South Texas Project Electric Generating Station P.O. Box 289 Wadsworth, Texas 77483

U7-C-STP-NRC-100056

South Texas Project  
Units 3 and 4  
Docket No. 52-001  
Response to Request for Additional Information

This letter provides the response to Request for Additional Information (RAI) Letter Number 12 question 03.02.02-1 related to the application to amend the ABWR DCD Amendment Part 2, Tier 2, Section 3.2.

FIGURE 6.2-39 ATMOSPHERIC CONTROL SYSTEM P&ID (Sheet 2 of 3)  
ABWR DCD/Tier 2 Rev.5

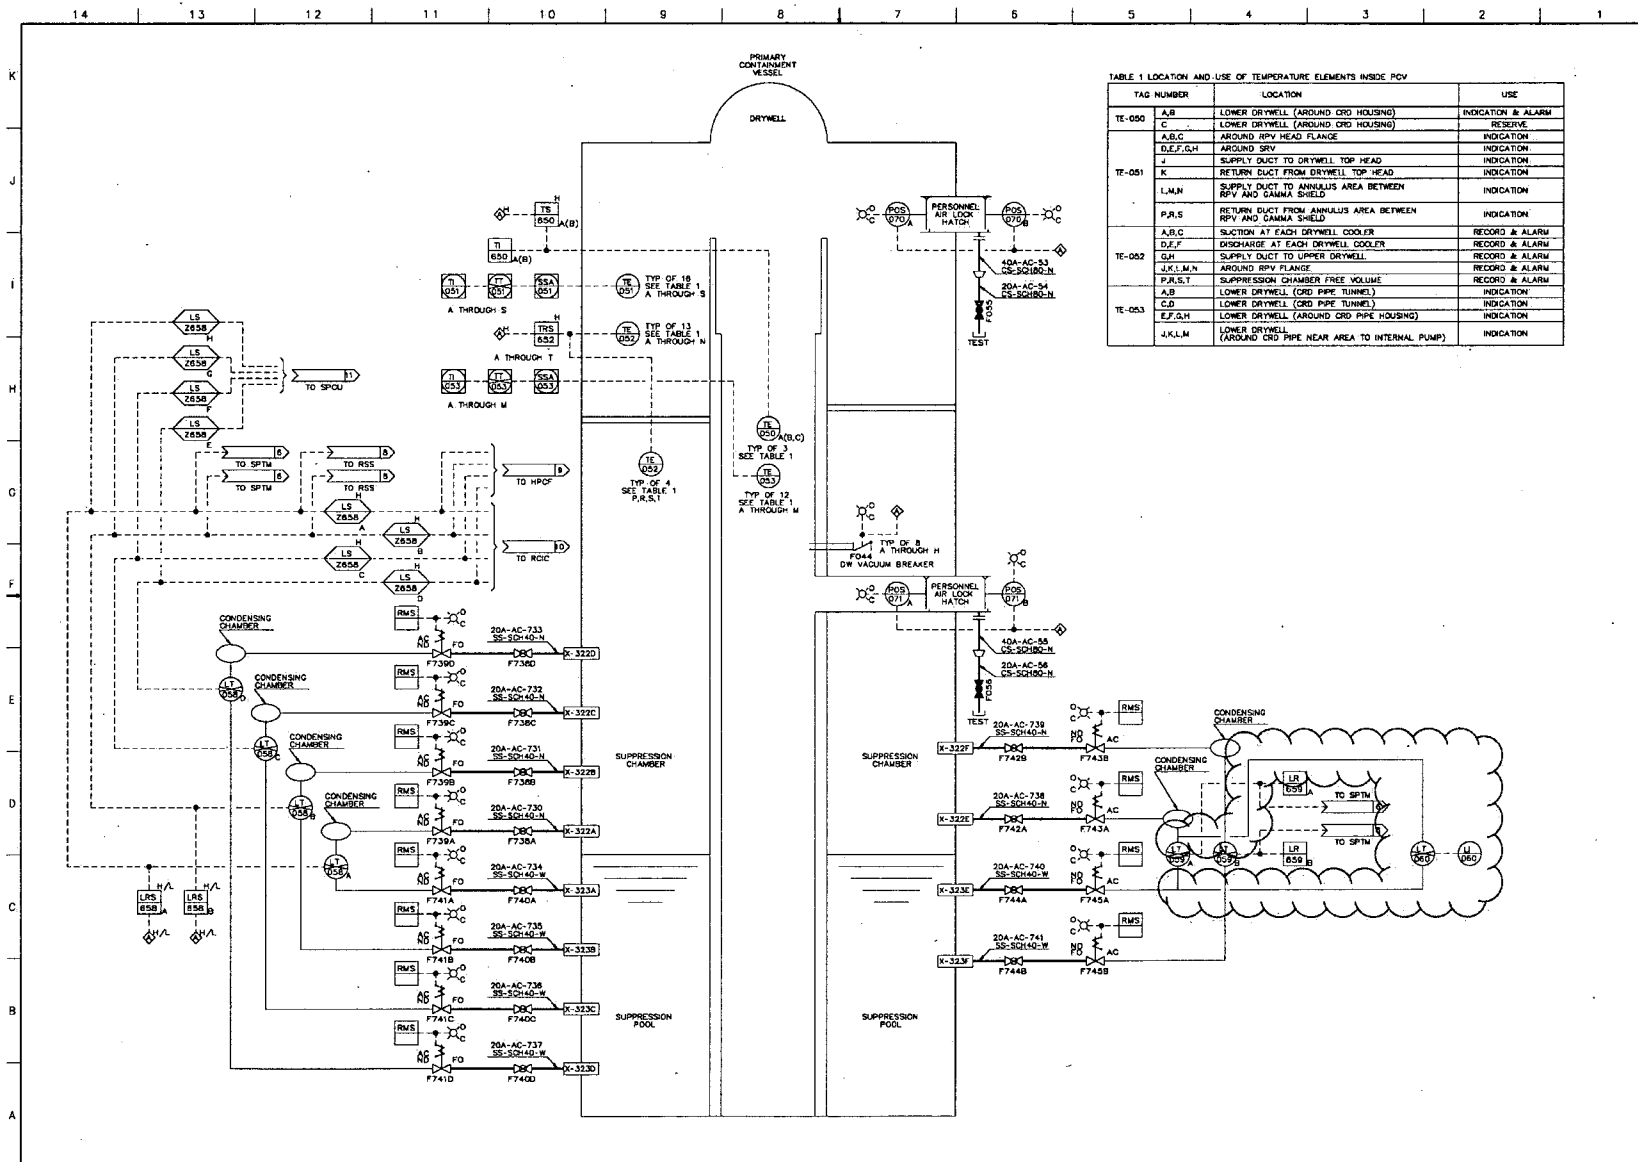
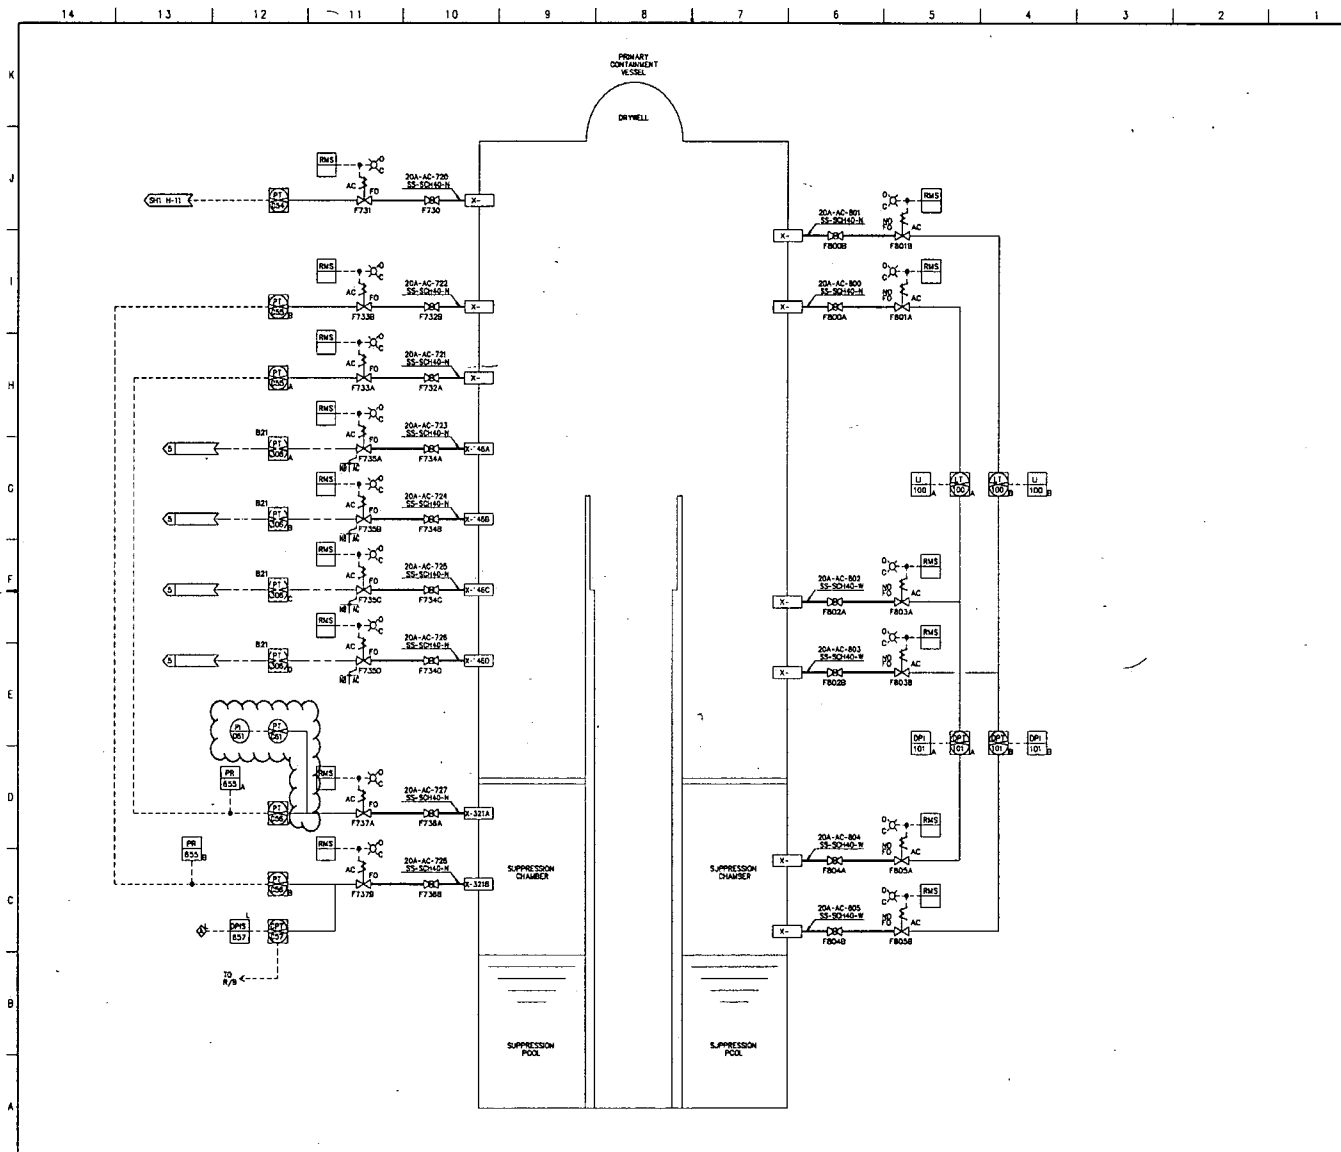
The staff request the applicant to clarify how and where the connection is made from which the AFI system gets its instrumentation signals and to demonstrate that the instrumentation included in the new AFI system does not create any potential for inadvertent actuation or creates challenges to current safety systems.

The instrumentation connections for the AFI system are shown in the marked-up drawings for FSAR Figure 5.1-3, Sheet 5 provided in the original amendment application submittal and in updated Figure 6.2-39, Sheets 2 and 3, attached to this RAI, which supersedes the Figure 6.2-39 markups provided in the original submittal. There are no automated control systems or functions for the AFI system, because it is a manually operated system. The instrumentation for the AFI system only includes indicators that are for operator information. In addition, the water level and pressure instrumentation in the AFI pump room uses separate transmitters and power supply from existing instrumentation. As noted in the response to RAI 03.02.02-1, the safety classification of the instrumentation and piping for the AFI system is the same as that for the existing instrumentation to which it is connected. Those requirements are identified in a mark-up to Table 3.2-1 which is included with that response. Consequently, the AFI system does not create any potential for inadvertent actuation or challenges to current safety systems.
